**TRANSMITTAL OF RESPONSES TO ADDITIONAL COMMENTS ON THE REVISED PROJECT SPECIFIC PLAN FOR DIRECT-PUSH GROUNDWATER SAMPLING IN FORMER SOIL EXCAVATION AREAS**

**RESPONSES TO COMMENTS ON THE  
REVISED PROJECT SPECIFIC PLAN FOR  
DIRECT-PUSH GROUNDWATER SAMPLING IN  
THE FORMER SOIL EXCAVATION AREAS  
(REVISION 1)**

**FERNALD CLOSURE PROJECT  
FERNALD, OHIO**

FIGURE 1. PROPOSED DIRECT-PUSH GROUNDWATER SAMPLING LOCATIONS IN GMA BENEATH EXCAVATION AREAS 3A AND 4A

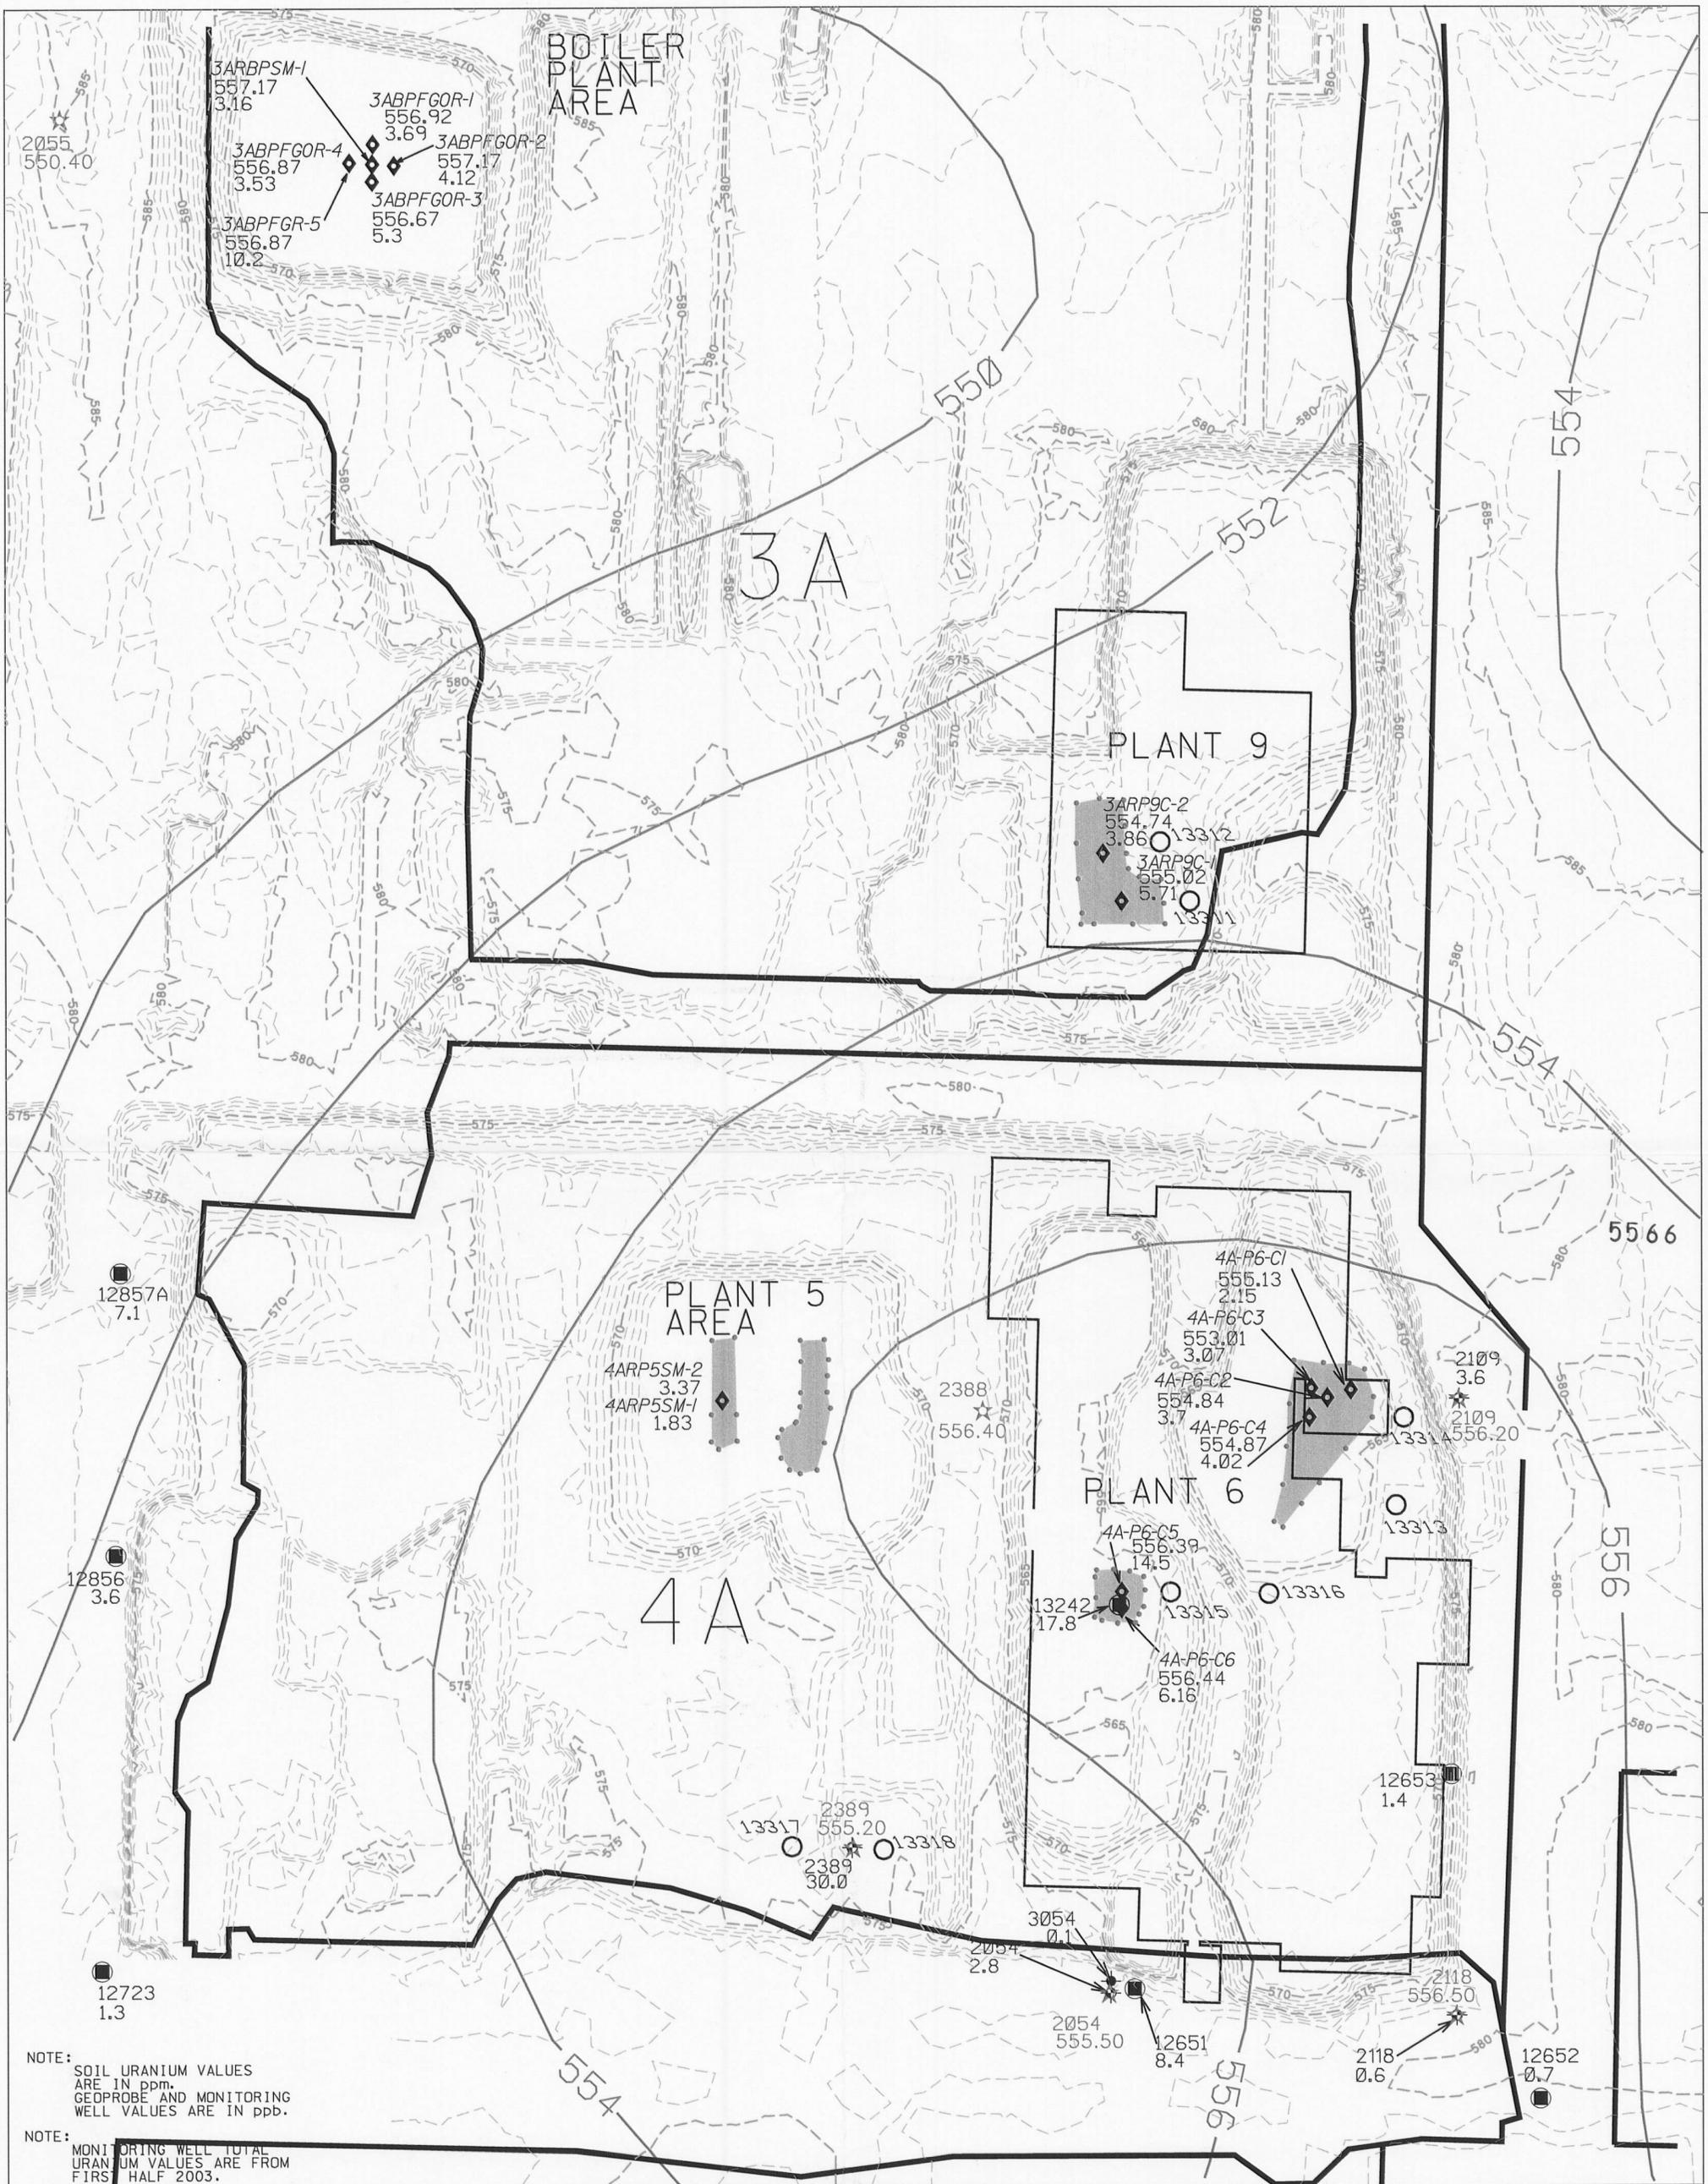
Comment: The borings that are located at the bottoms of the excavations should be relocated. They should be moved to the east so that they are on the berms and not the bottoms of the excavations.

Comment: The text states, "However, a location movement of less than 25 feet will not require a variance." This is acceptable, but no boring should be moved to a location where water will pond.

Response: The borings that were located on the bottom of the excavations (Locations 13311, 13314, and 13315) have been relocated. They are now situated outside the deep excavations in areas where water does not pond. Figure 1 has been updated and attached to these comment responses to show the new locations. In the Plant 9 area, moving Location 13311 east put it very close to Location 13312. It was, therefore, decided to move Location 13312 to a new location north of 13311. In the Plant 6 area, moving Location 13313 east placed it right next to Location 13314. Therefore, location 13313 was moved to the south of Location 13314.

Response: Agreed. No borehole will be moved to a location where water will pond. Preliminary Conceptual Restoration Plans also indicate direct-push locations are not located in any spillways or channels that will remain after restoration.
